February 12, 2018

SUBJECT: ARKANSAS NUCLEAR ONE, UNITS 1 AND 2 – FLOOD HAZARD MITIGATION
STRATEGIES ASSESSMENT (CAC NOS. MF7894 AND MF7895; EPID L-2016-
JLD-0007)

STAFF ASSESSMENT RELATED TO THE
MITIGATION STRATEGIES FOR
ARKANSAS NUCLEAR ONE, UNITS 1 AND 2
AS A RESULT OF THE REEVALUATED FLOODING HAZARDS REPORT
NEAR-TERM TASK FORCE RECOMMENDATION 2.1- FLOODING
CAC NOS. MF7894 AND MF7895

Figure 3.2-1 FLEX Equipment Deployment Routes and Staging Location (adapted from Figure A-1 of Entergy's May 31, 2017, submittal (ADAMS Accession No. ML17153A295))

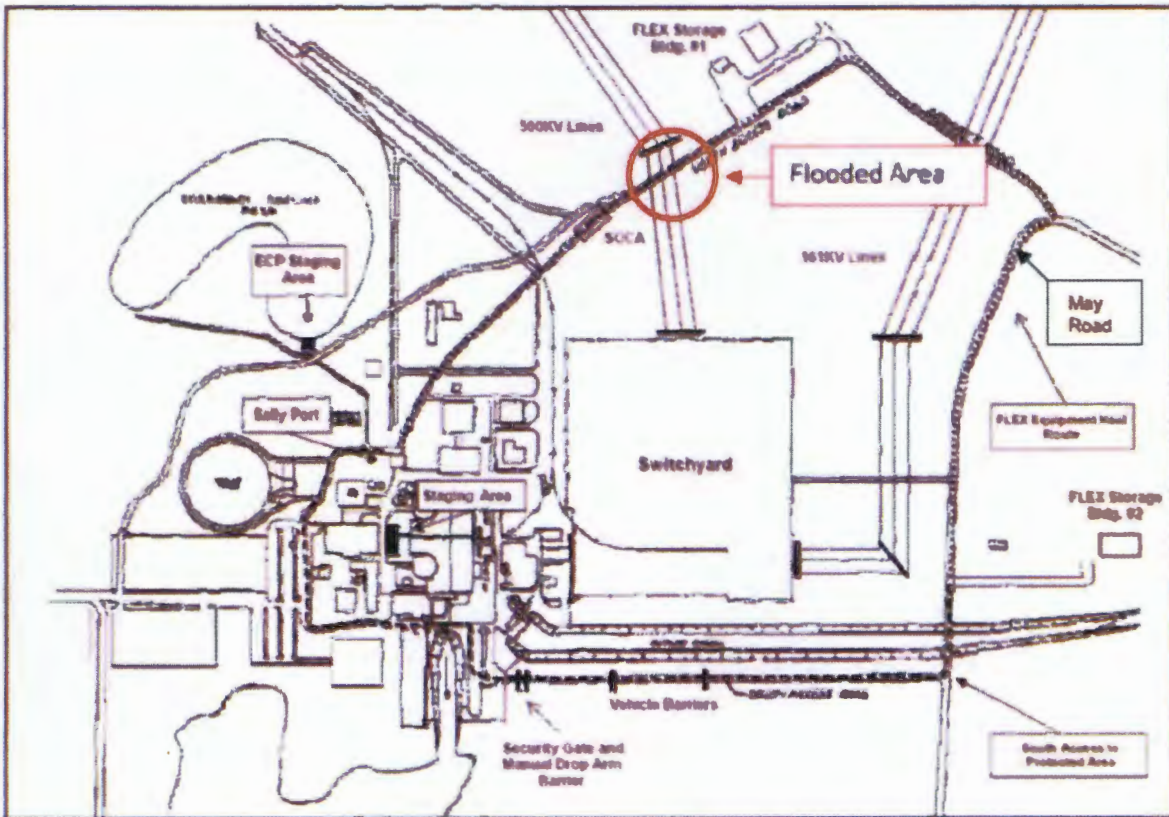
The ISR provides reevaluated LIP flood heights in the range of 351.4 feet (ft.) to 357.7 ft. National Geodetic Vertical Datum of 1929 (NGVD29). The equipment stored in FLEX Storage Building (FSB) #1 is at an elevation of 412.8 ft. This elevation is higher than the surrounding area and therefore storage of the equipment is not impacted in this building. The deployment pathway from FSB #1 along the North Access Road has a section, approximately 360 ft. long, where maximum flood heights exceed 5.5 ft. This section only begins to fully recede after 6 hours and is expected to become passible after 9 to 10 hours. Figure 3.0-1 provides a diagram showing the location of the flooded area. Deployment of FLEX equipment, which starts as early as 3 hours could be impacted by these flood heights.

Regarding the equipment stored in FSB #2, the FSB elevation is higher than the expected LIP flood levels at this location; however, there is significant flooding expected between this FSB and May Road. The flood heights can reach greater than 8 ft. and are expected to recede at a later time than the flood area along the North Access Road.

The licensee evaluated flood levels around the FLEX staging area and associated activities around the power block and determined that these activities are not impacted. The licensee's MSA notes that the FLEX design basis flood strategy credits pre-deployment activities several days in advance of the LIP event. As discussed in the staff's September 19, 2016, safety evaluation for FLEX, this includes installation of platforms for the Phase 2 equipment. For the LIP event, based on flood depths, the licensee has determined that the platforms do not need to be erected. The licensee reviewed the associated activities, including the FIP sequence of events timeline, and determined that these activities can be implemented as intended assuming equipment from FSB #1 is staged prior to inundation of the North Access Road haul path from the LIP event.

The staff notes that based on the FHRR, the flooding around the staging area (see Figure 3.2-1) is minimal and below the ground clearance of the FLEX equipment. The licensee also included a commitment in its MSA to either establish trigger-point entry conditions and appropriate procedural changes to prestage the FLEX equipment or to modify the road such that the deployment path is not affected by the LIP. Since warning time is available prior to the onset of the LIP, the NRC staff finds it reasonable that the modified FLEX strategy (i.e., prestaging of FLEX equipment) can be implemented as intended. Alternatively, the staff notes that modifications to the FLEX strategy would not be needed if the licensee changes the North Access Road elevation such that deployment of the FLEX equipment is not impacted by the LIP event.

- Pre-deploy the FLEX 480 V generator, supporting trailers, and other equipment to the anticipated staging area for a LIP event. The licensee's MSA states that trigger-point entry conditions will be developed and integrated into the licensee's operational procedures such that manual actions to deploy and operate the equipment would not be impacted by the ponding during a LIP event. The licensee provided an alternative to modify the section of the North Access Road that becomes inundated by raising an approximate 360 ft. long section of the road such that the FLEX strategies could be implemented without the need for prestaging.
